**APPLICATION FOR THE 3RD AMENDMENT AND
~~CHANGE IN ZONING TO THE MPUD ZONING~~
~~DISTRICT, AND FOR THE SECOND AMENDMENT~~
~~(OVERALL)~~ TO THE LEGACY PARK (NORTH) @
SOUTHERN GROVES - MASTER PLANNED UNIT
DEVELOPMENT (MPUD) ZONING DISTRICT**

Application for Amendment to Master Planned Unit Development
City of Port St. Lucie Project Number: P26-054
PSLUSD Project No: 11-900-21

EXHIBIT A

AMENDMENT NO 3 (P26-054)

SECTION 8 – MPUD CONCEPT PLAN

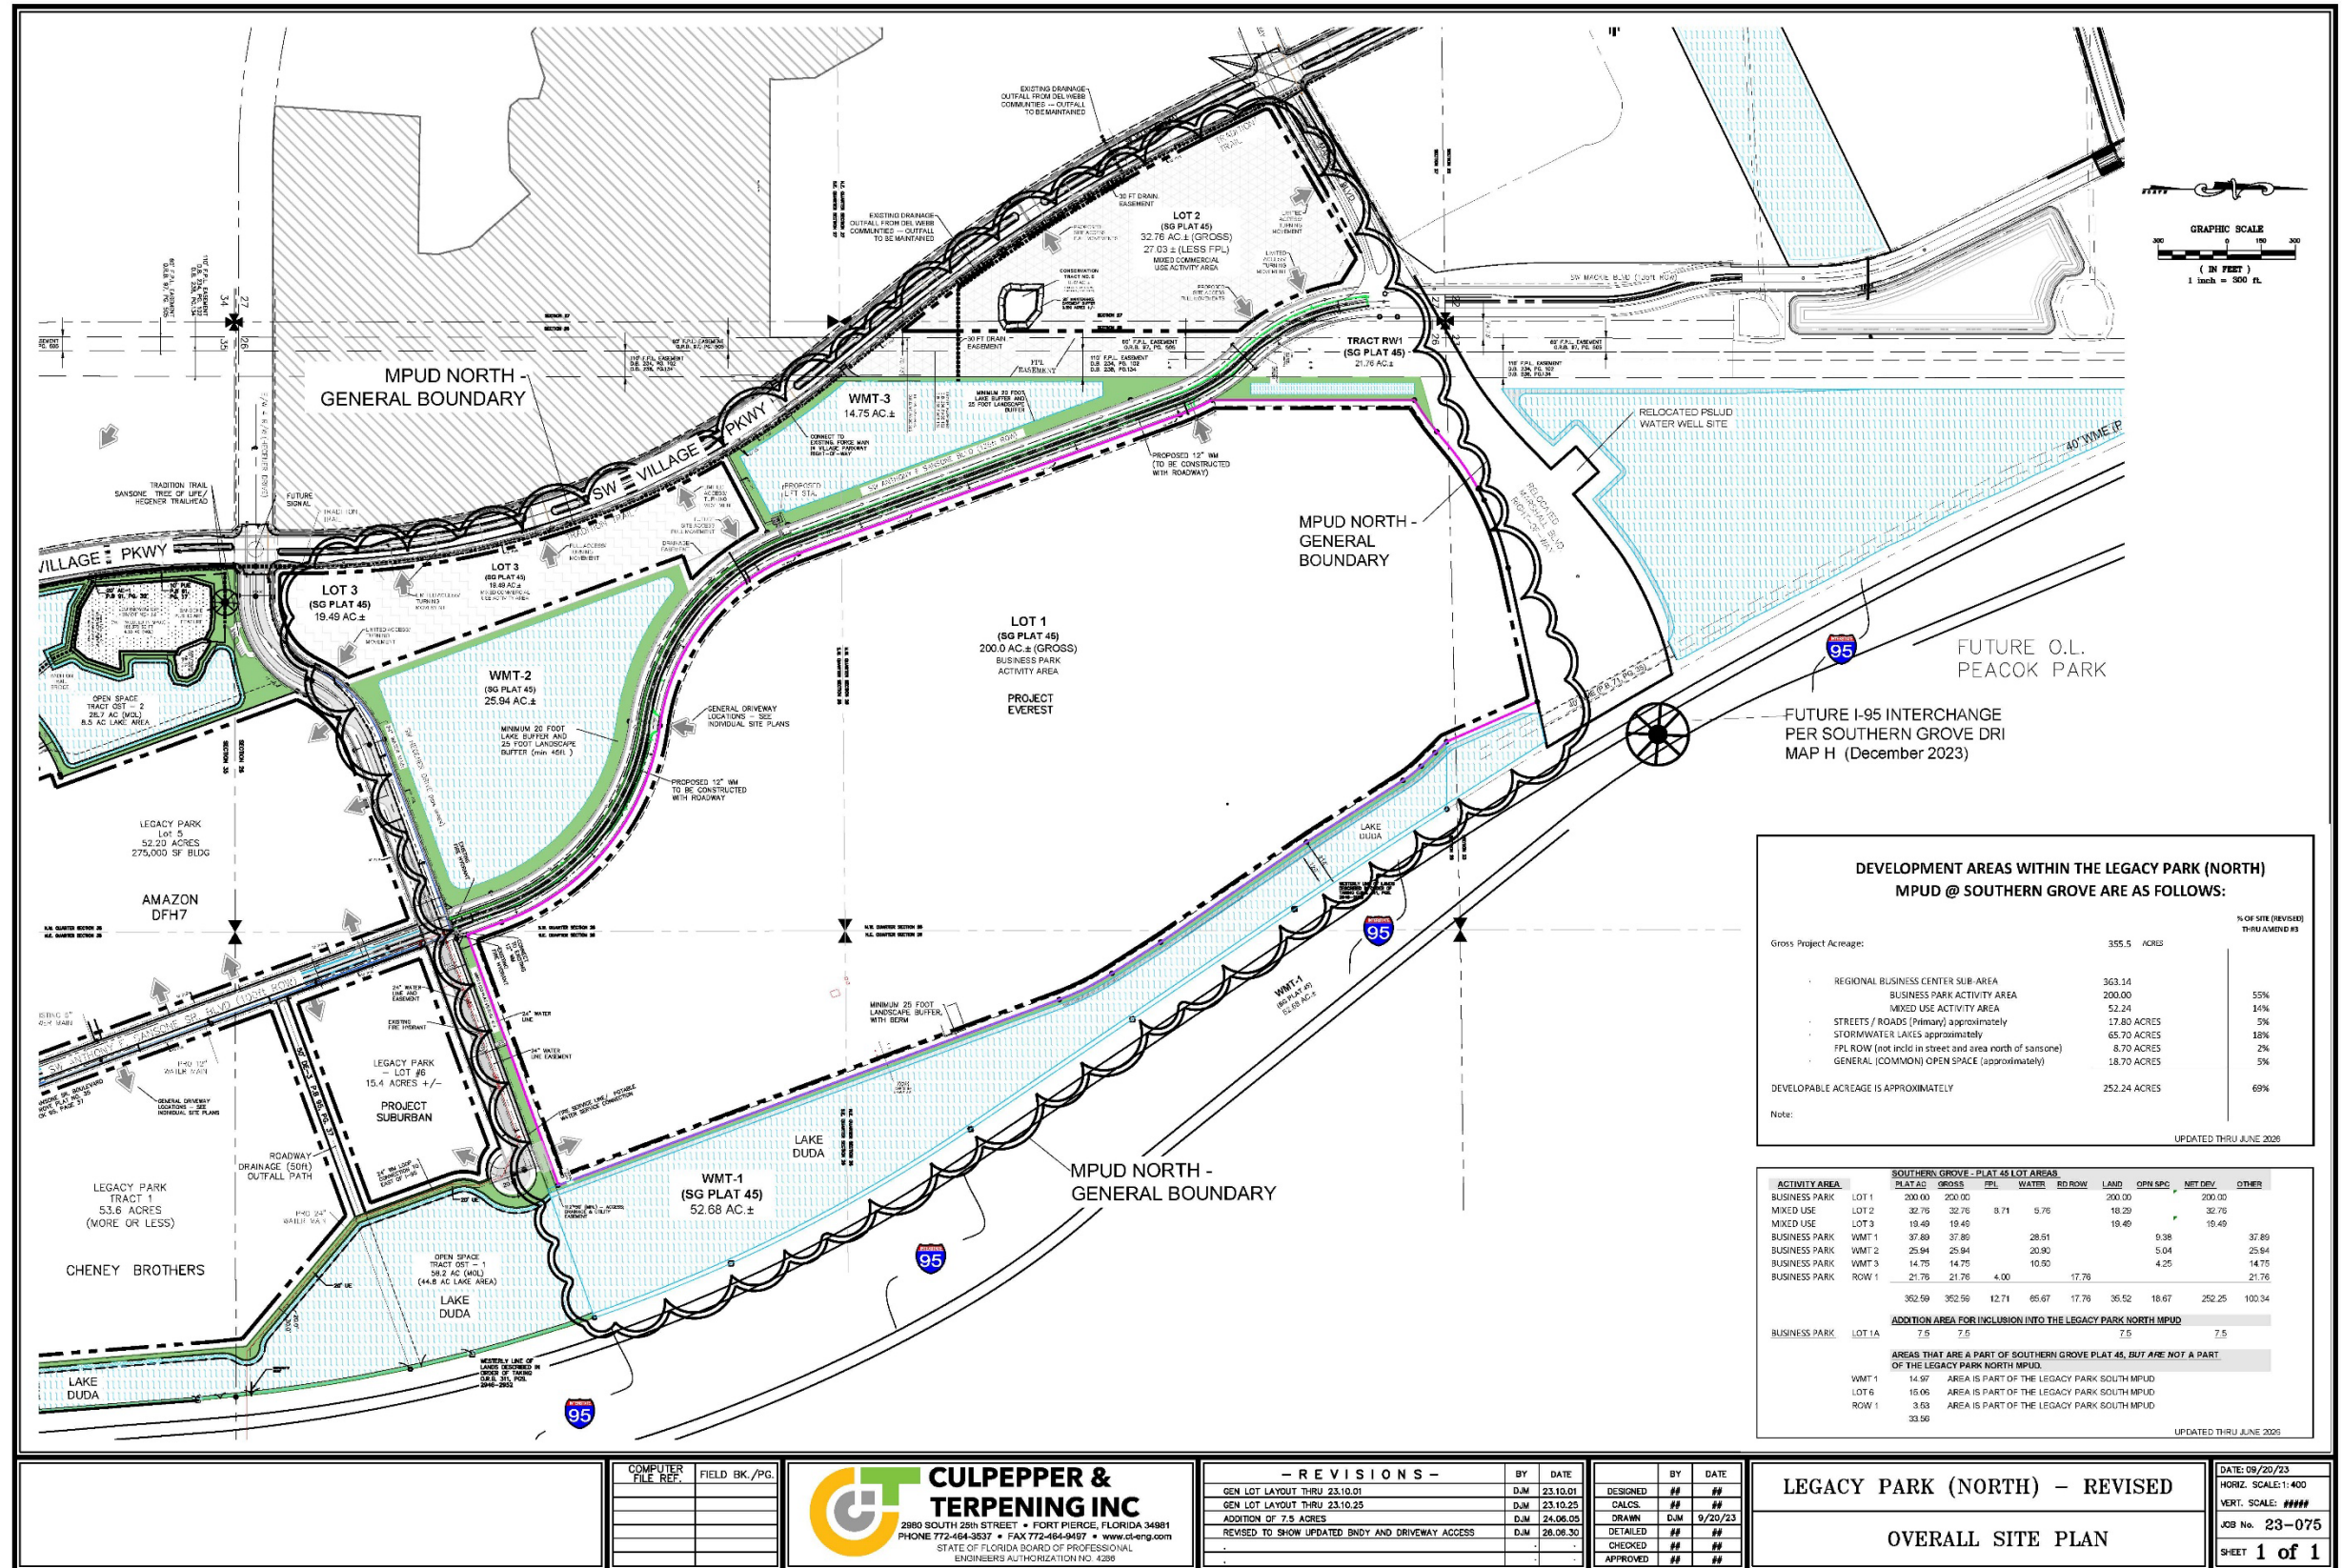
- 7) Revises the driveway locations for certain parcels on the MPUD conceptual plan
- 8) Other minor changes, corrections, and/or reformatting of text.
